Architectural Review and
Historic Preservation Board
Agenda Report

File: PDP 20-03

RE: Planned Development Permit 20-03 (Chico Eye Center); Northwest corner of Esplanade and DeGarmo Drive, APN 006-820-013.

Sheet Title
LANDSCAPE PLAN

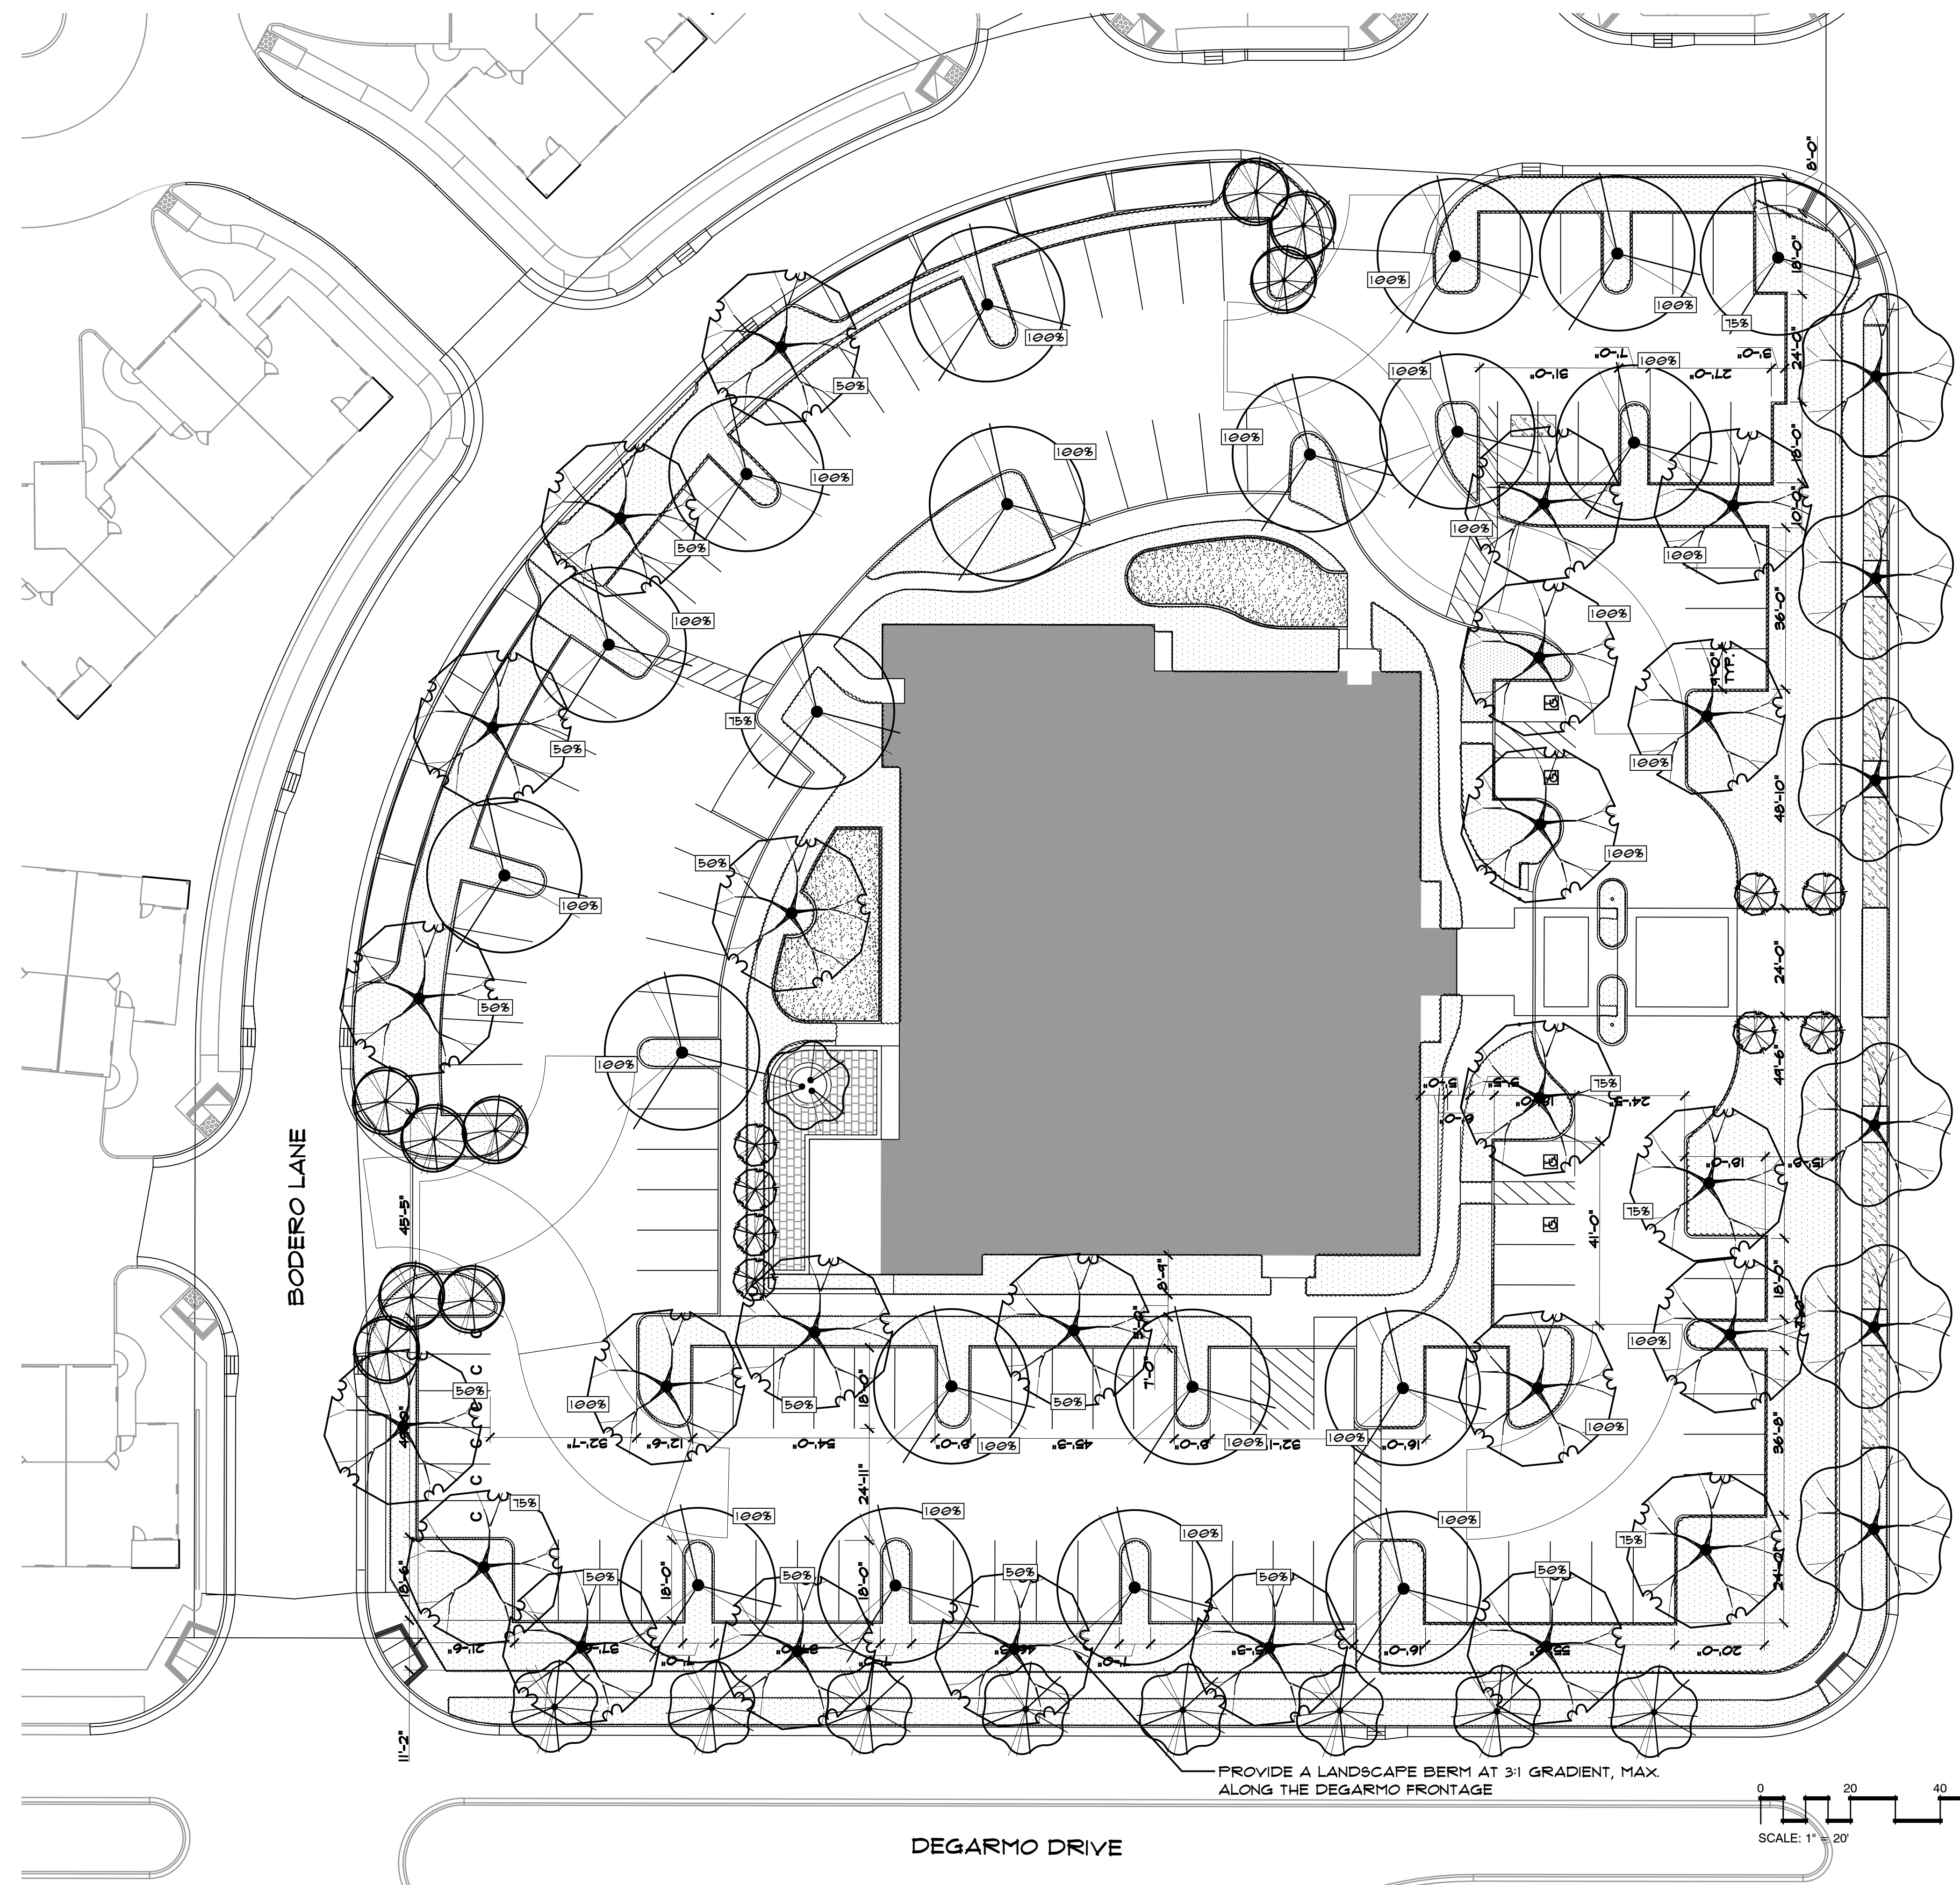
6. Applicant shall construct a landscaping berm as depicted on the landscaping plan along the DeGarmo Drive frontage to further shield views of the parking area.

PROVIDE A LANDSCAPE BERM AT 3:1 GRADIENT, MAX. ALONG THE DEGARMO FRONTAGE
